CITY OF ALBUQUERQUE

**RE: 5501 La Colonia Drive NW
5501 La Colonia Drive NW
Engineer's Stamp Date: 12/31/2021
Hydrology File: E12D042**

Based upon the information provided in your submittal received 01/03/2022, the Grading & Drainage Plan is approved for Grading Permit (earthwork can get started for the earth pad on the house).

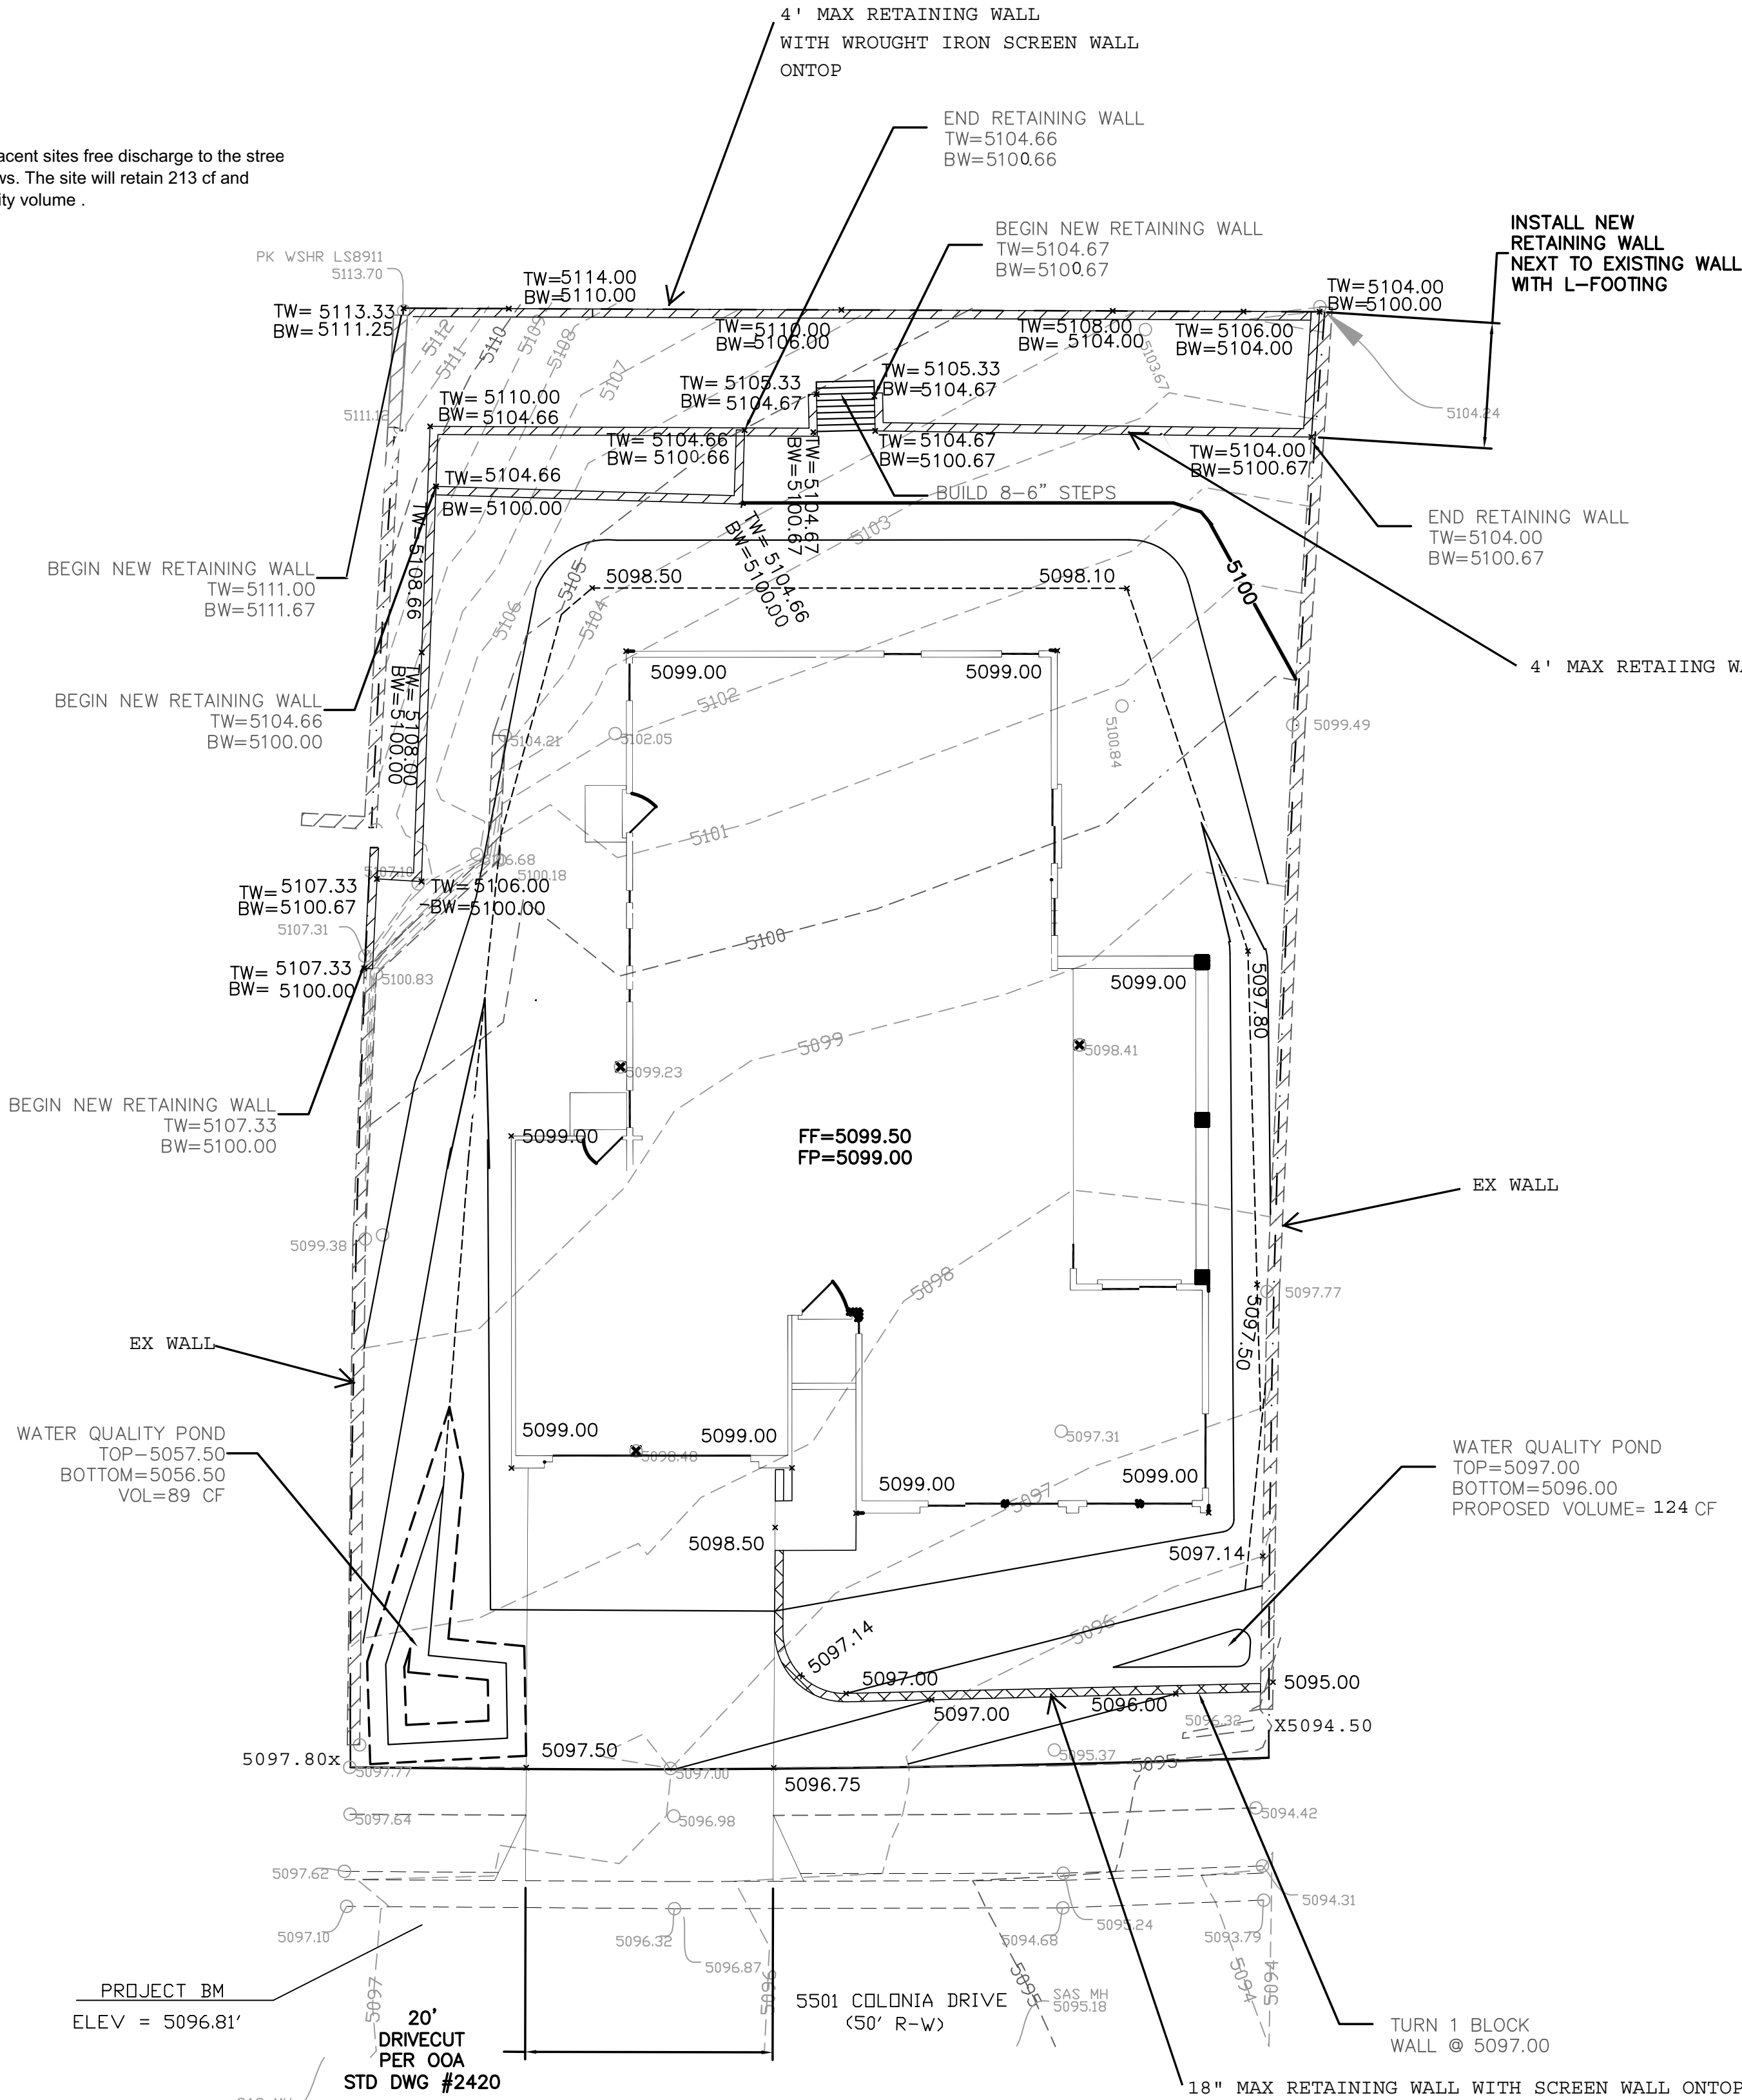
Once the grading is complete, a pad certification (meaning that the earthwork is complete) will be required prior to release from Hydrology during the Building Permit process. Also, at the time of pad certification approval, Hydrology will concurrently approve the Grading & Drainage Plan for Building Permit.
